ADMINISTRATIVE DECISION

APPLICANT REQUEST: Waiver of the 1-inch rain event Stormwater Management Plan retention requirements.

THE WHARF
KATHERYN JENSON
CROSSLAKE, MN
STORMWATER MANAGEMENT PLAN

SHEET NO.
C1.0

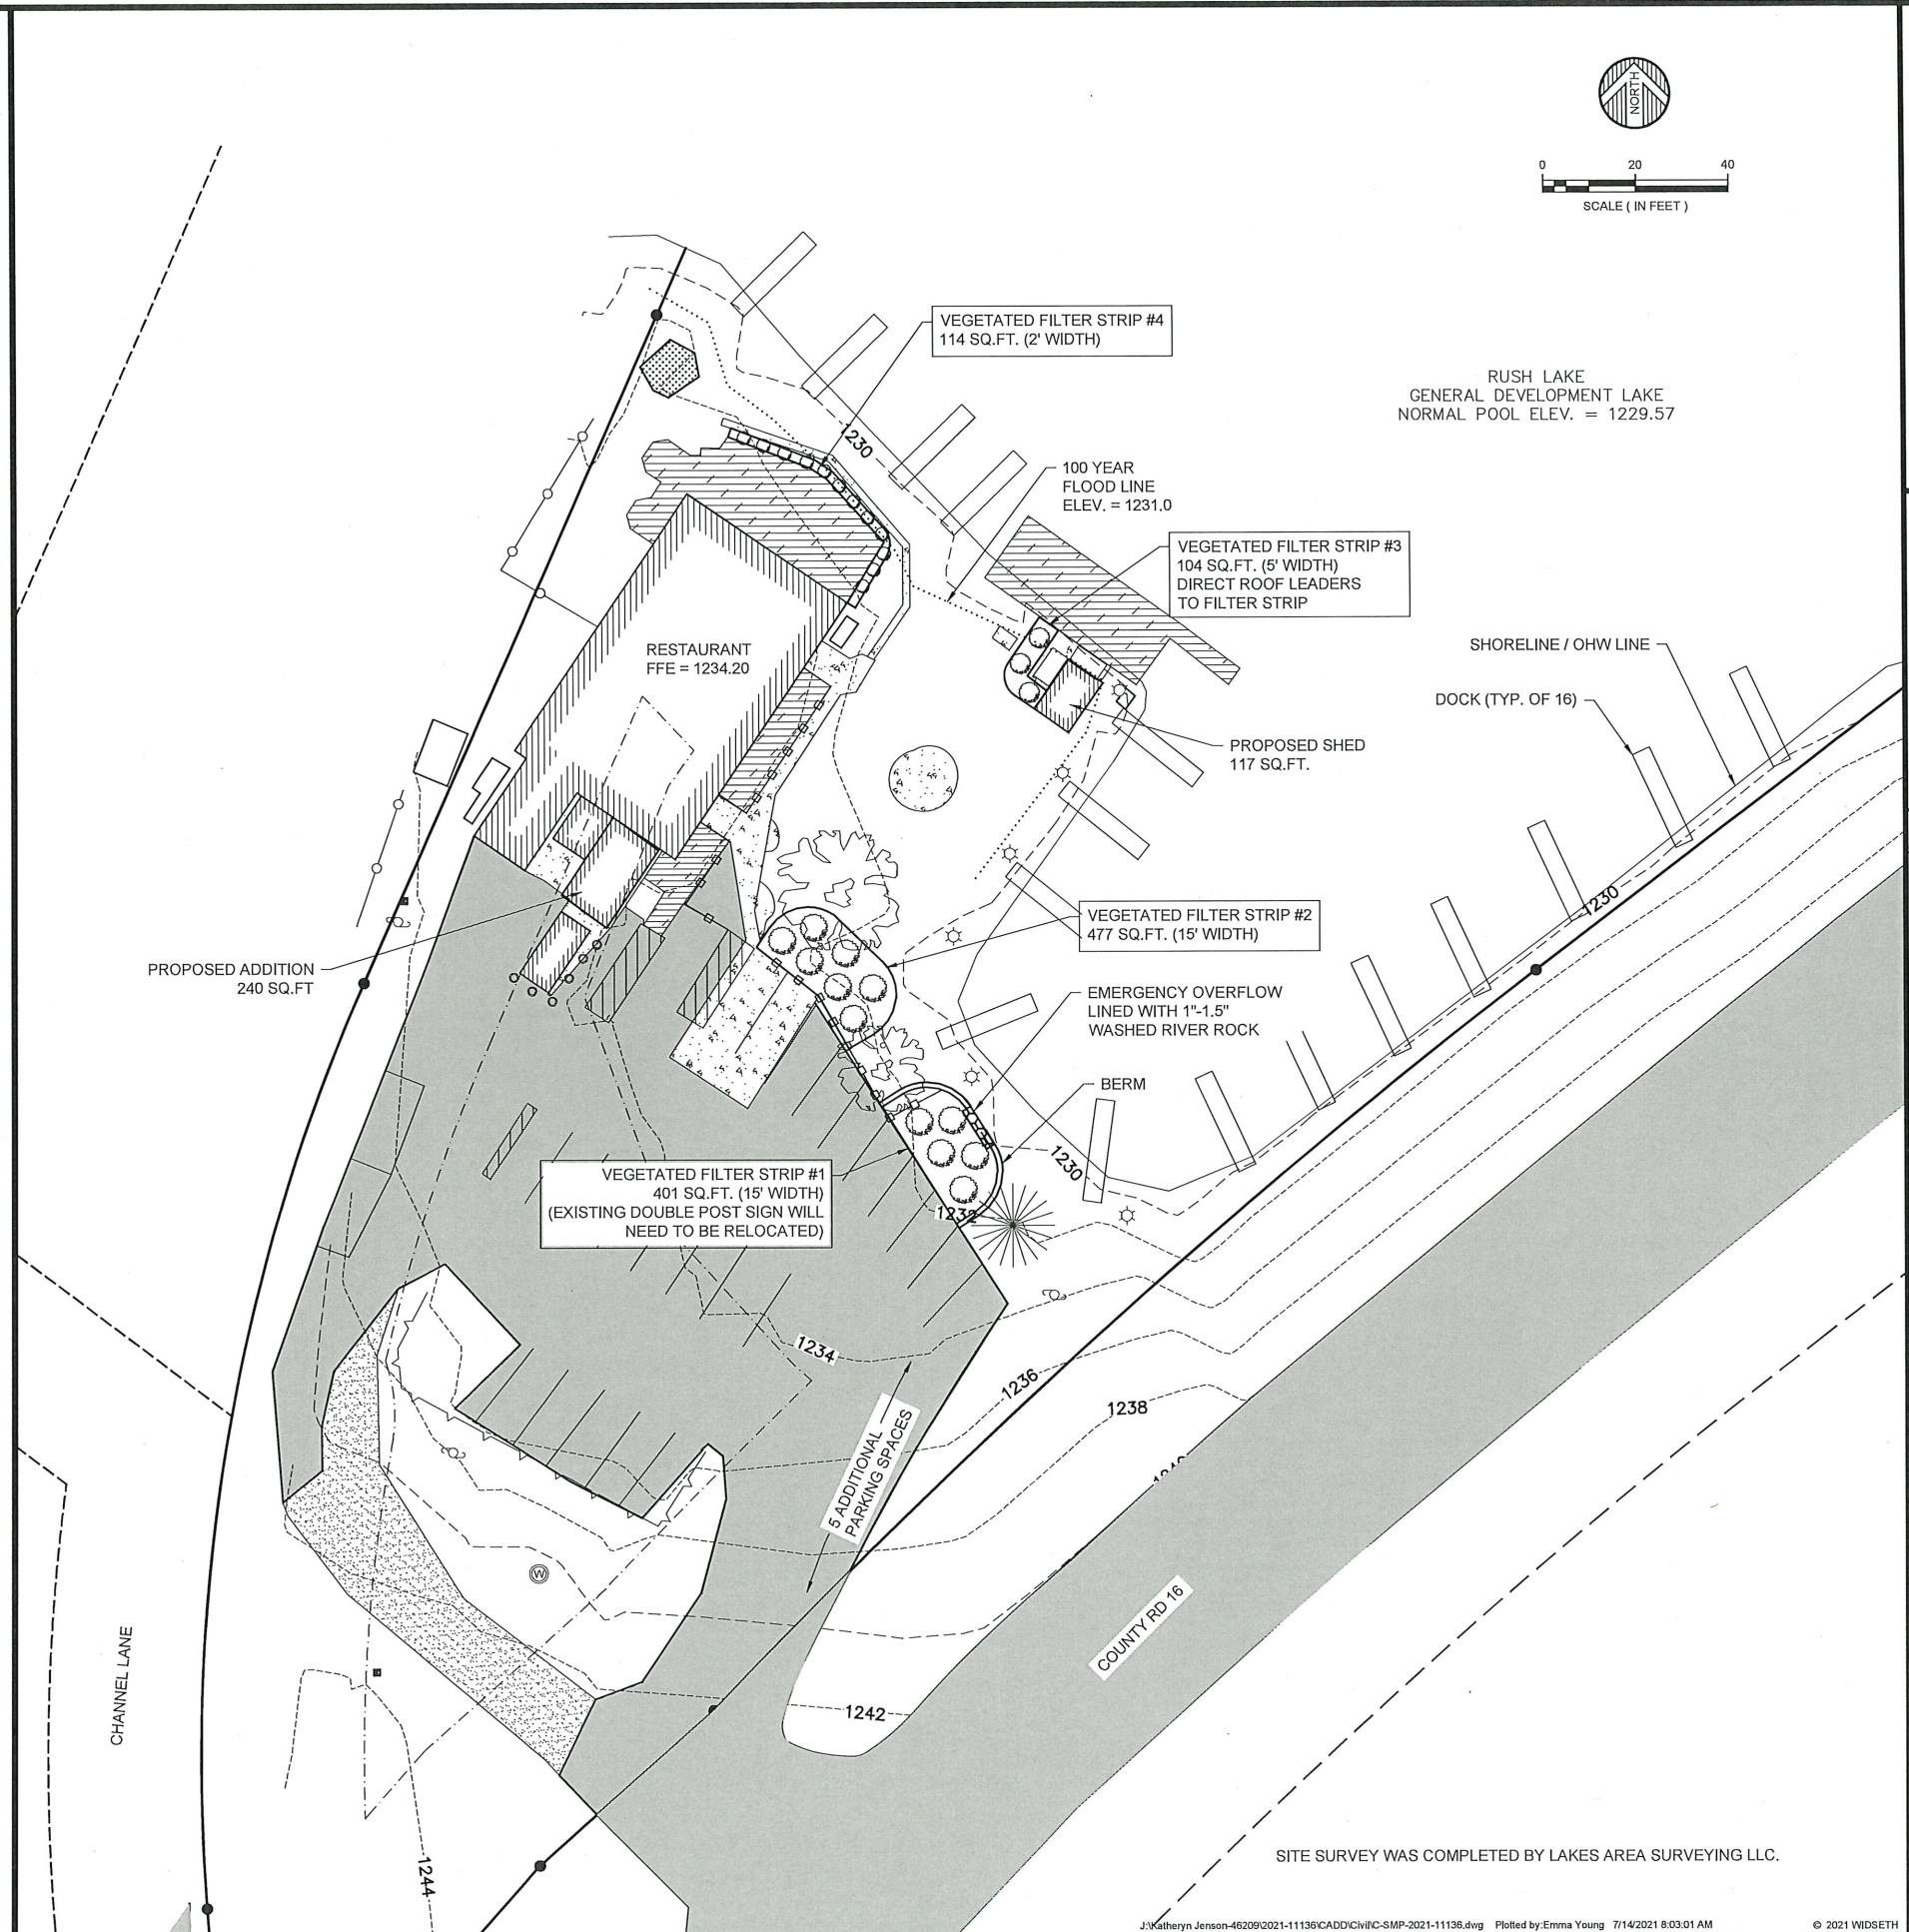
ISSUE: The Owner of the Property applied for and was approved to construct two small additions on the property at the May 28, 2021 Planning Commission/Board of Adjustment meeting. A requirement for the Variance application and any subsequent Land Use Permits to build the approved structures, required an engineered Stormwater Management Plan that accommodates a 1-inch rain event flowing off all the impervious surface on the property. The Engineering firm was unable to accomplish the retention of all of the volume of water per the requirements.

FACTS: The business has been at its current location since at least 1970, prior to any Land Use Restrictions being implemented by the city. The existing site conditions (available green space, depth to groundwater, impervious coverage, etc.) do not allow for the storage and infiltration of 1-inch of run-off from the impervious surface area. The required 3-feet of vertical separation cannot be attained due to the property elevation and the groundwater elevations. The plan submitted by your engineer is the best feasible alternative.

ANALYSIS: Due to the fact that no stormwater management is currently in place on the property and the engineer's determination that a very limited amount of retention is viable, it is not possible for the property owner to comply with the Land Use Ordinance Stormwater retention requirements.

DECISION: Through no fault of their own and not for lack of effort, the City shall accept the submitted Stormwater Management Plan from Widseth, dated 7/14/2021 and allow for the construction of the Proposed additions per the approved Variance application from 5/28/2021. No further expansion of impervious surface shall be allowed without seeking a variance from the city.
